Village of Bronxville
Site Development Application

Project Name, If Applicable: The O'Hara Residence

PLAN REVIEW COMMENTS

DESCRIPTION OF WORK : Front portico/kitchen/dining/family room/mudroom addition design at first floor and master suite/bedroom/bathroom addition design at second floor.

PLOT PLAN & ZONING INFO SCHEDULE

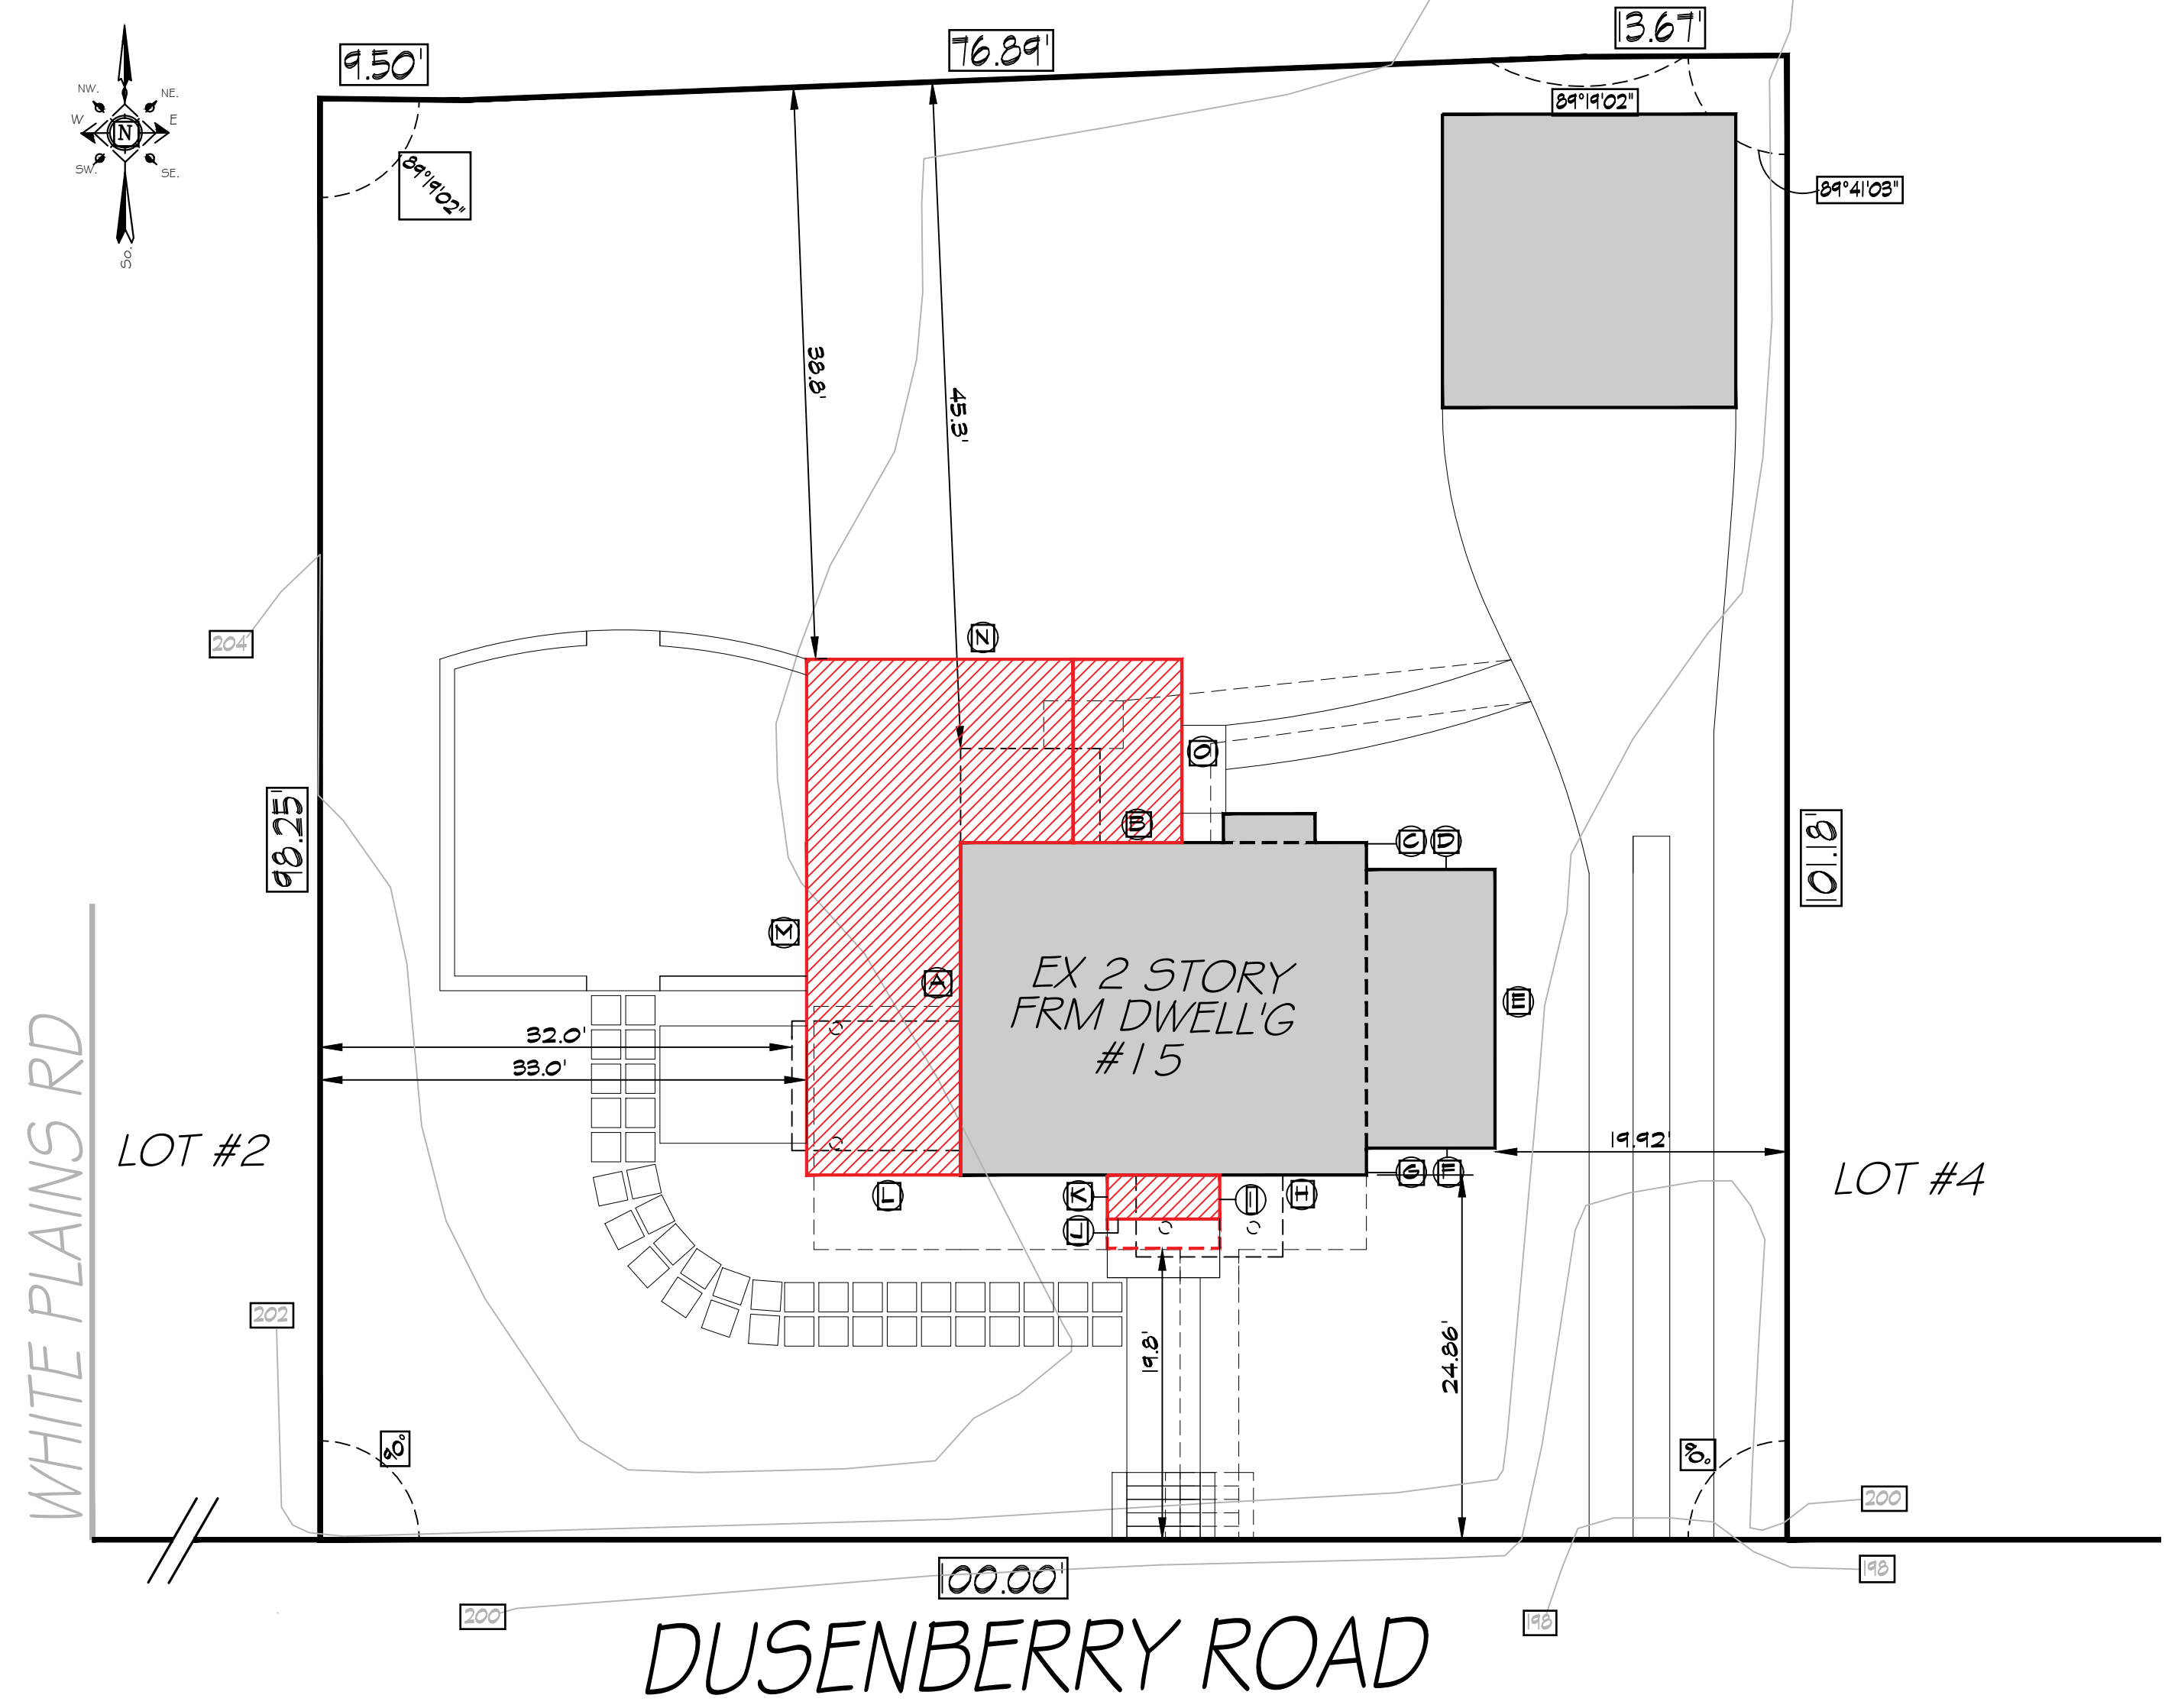
- 1) Building Coverage as per 310-10 exceeds maximum 22 1/2 %
- 2) Front Yard setback - 30', proposed front yard setback 19.8"
- 3) FAR (proposed) is .25. Existing FAR - .15; 30% maximum increase = .045; proposed increase = .195. As per 310-26 D (1) (b) [1] maximum FAR increase is 30%, proposed work exceeds the maximum 30% FAR Increase

As per 1 & 2 above referral to zoning is required

As per # 3 above referral for site plan development is required.
